Supplement Sheet

Subject: Installation of Chipper-Shredder-Vac Chute Assembly 631-0083

PURPOSE: This supplement sheet provides instruction for the correct setup of the switch activation bracket on the 631-0083 CSV Chute Assembly.

FIGURE 1

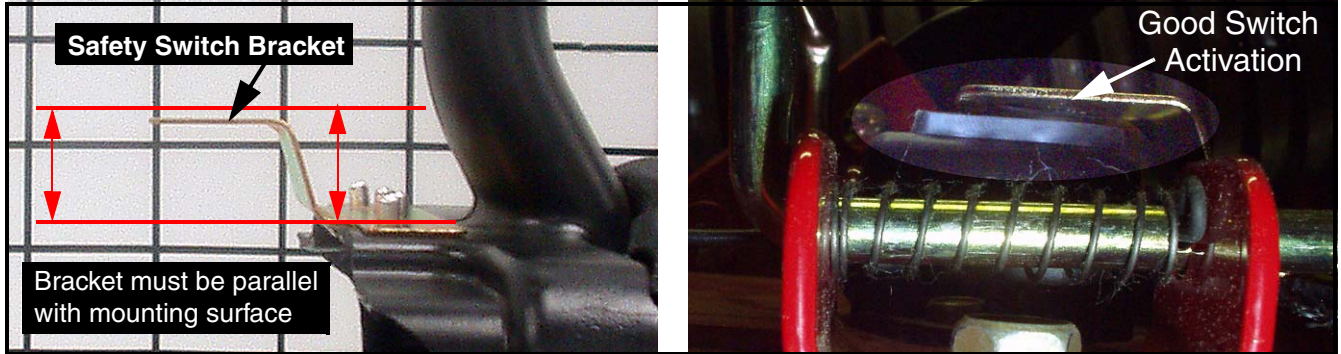
1. Inspect the Chute Assembly to ensure that the safety switch bracket is formed as shown in Figure 1.

FIGURE 2A

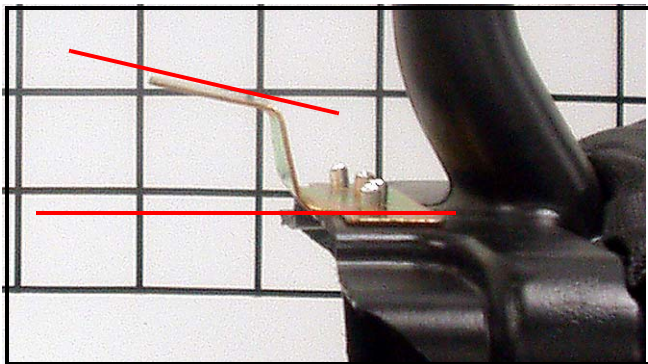
2. If the safety switch bracket is bent as shown in Figure 2A, the safety switch may not be sufficiently depressed (activated) resulting in the engine not starting (i.e. ignition grounded).

3. To correct a bent safety switch bracket, use a pair of pliers and grip the safety switch bracket's tab as shown in Figure 3. While holding the chute assembly from moving, apply a bending moment in the direction necessary to bring the tab into the position shown in Figure 1.

FIGURE 2B

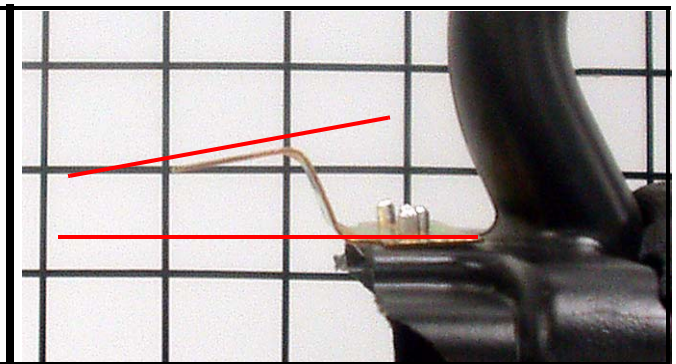
If the safety switch bracket is bent as shown in Figure 2B, the chute assembly may not install properly also resulting in the engine not starting.
